WALKER
MANUFACTURING CO.

ADVISORY BULLETIN #22288

SUBJECT: Changes to the Jackshaft Assembly Design

MODELS AFFECTED: MT and MC tractors prior to S/N 2022-175934

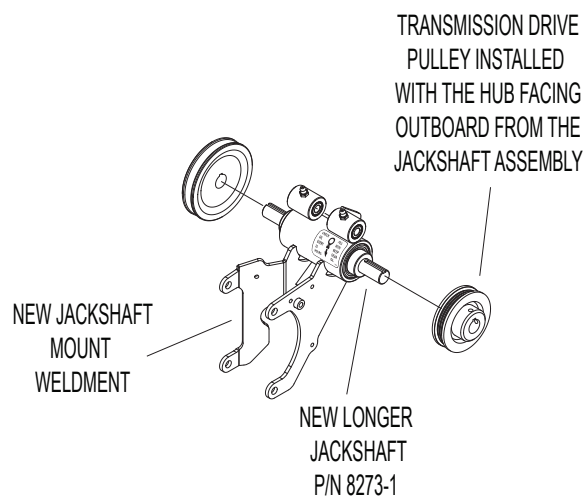
PURPOSE: The jackshaft assembly was redesigned for improved durability resulting in a longer jackshaft and a new mount weldment. To accommodate these changes, the transmission drive pulley must be installed with the hub facing outboard from the jackshaft assembly for the ground drive belt to properly align.

When replacing just a jackshaft, be sure to order the correct one. The previous jackshaft mount has a bearing housing that measures 3-3/4" which requires the shorter jackshaft (7-1/2"), P/N 8273. The new jackshaft mount assembly has a bearing housing that measures 4-1/4".

When replacing an entire jackshaft assembly, order the Hydro Jackshaft Mount Kit which comes with the new longer jackshaft (8-1/8").

1. Hydro Jackshaft Mount Kit, P/N 8394-6 (includes #2)
2. Jackshaft (3/4 x 8-1/8), P/N 8273-1
